VISTA CHEMICAL COMPANY

ABERDEEN, MISSISSIPPI

HAZARD AND OPERABILITY STUDY

NEW MODULE

PROCESS & INSTRUMENTATION DIAGRAM
NEW MODULE
HOT WATER CHARGE & RINSE SYSTEM
SHEET 2 OF 2

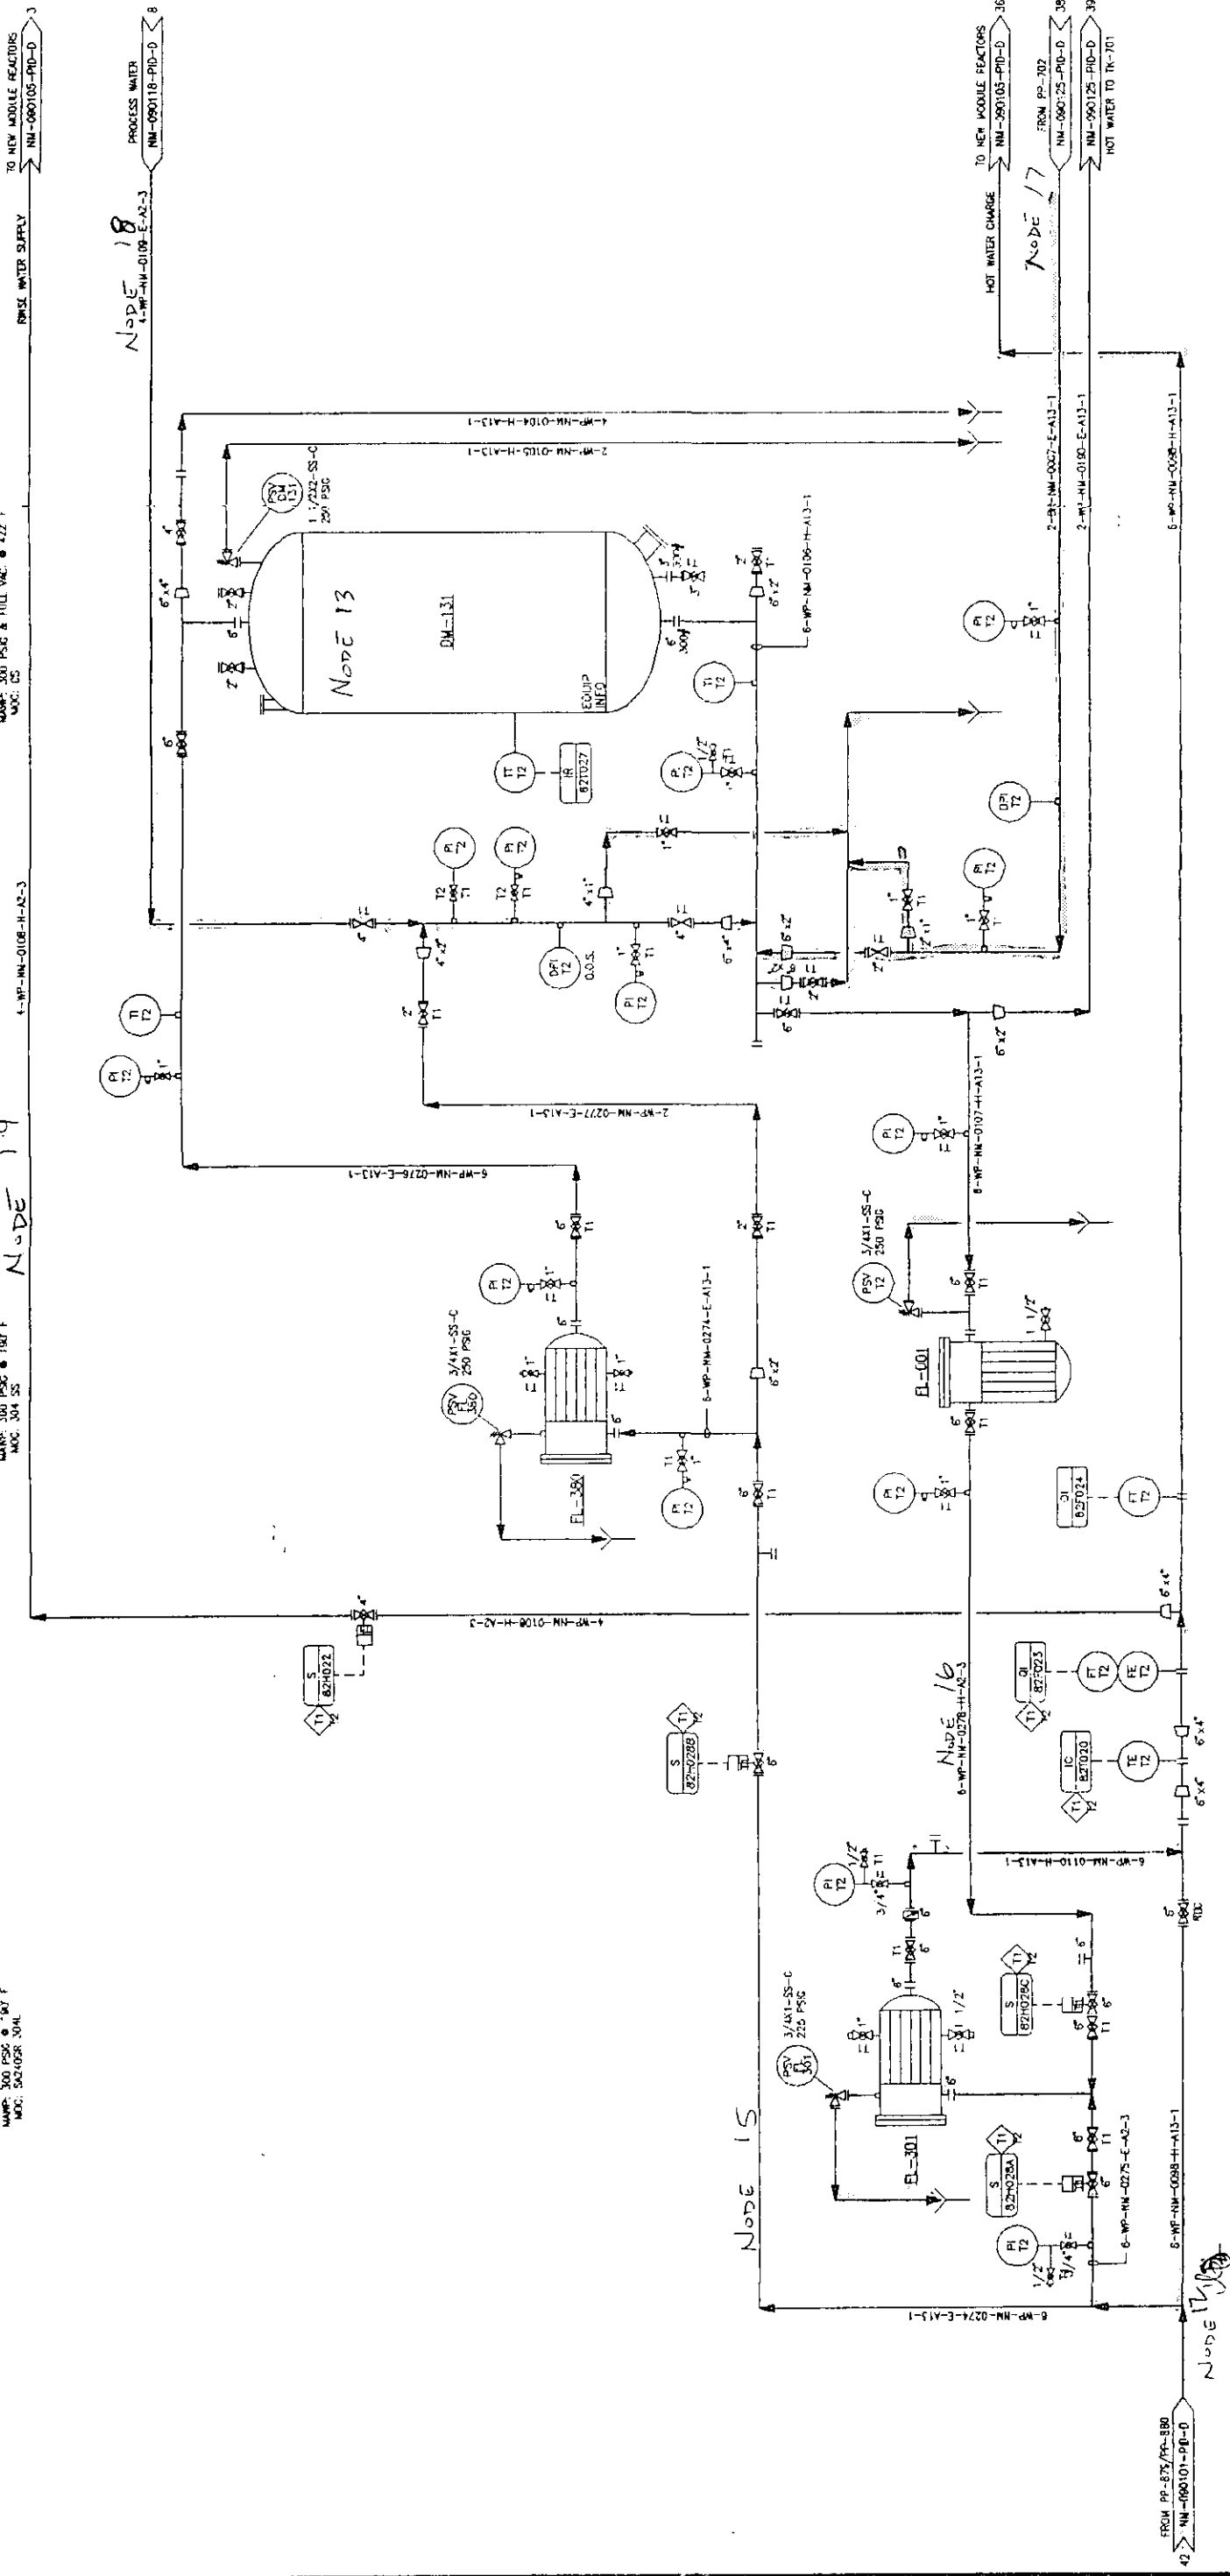
Aberdeen New Module HAZOP		
Equipment/Line Description: Hot Water Charge Tank Drawing No. NM-090101-PID-D		
Deviation: High Level		
Cause: 1. INLET VALVE MALFUNCTION 2. HIGH LEVEL SWITCH MALFUNCTION		
Consequences: 1. OVER FILL TANK WASTE WATER & HEAT 2. ALGAE GROWTH ON WALKING SURFACES IF OVER FLOWS FOR EXTENDED PERIODS.		
Safeguards: 1. LEVEL INDICATOR 2. OVER FLOW PIPE 3. HIGH LEVEL ALARM 4. SIGHTGLASS		
Consequence Rating: IV	Probability Rating: B	Risk Ranking: 5
Action/Other Considerations: 1. P&ID WRONG ADD LEVEL XMITTER TO BOTTOM OF TANK. LT SHOWN AT TOP OF TANK IS ACTUALLY LS.
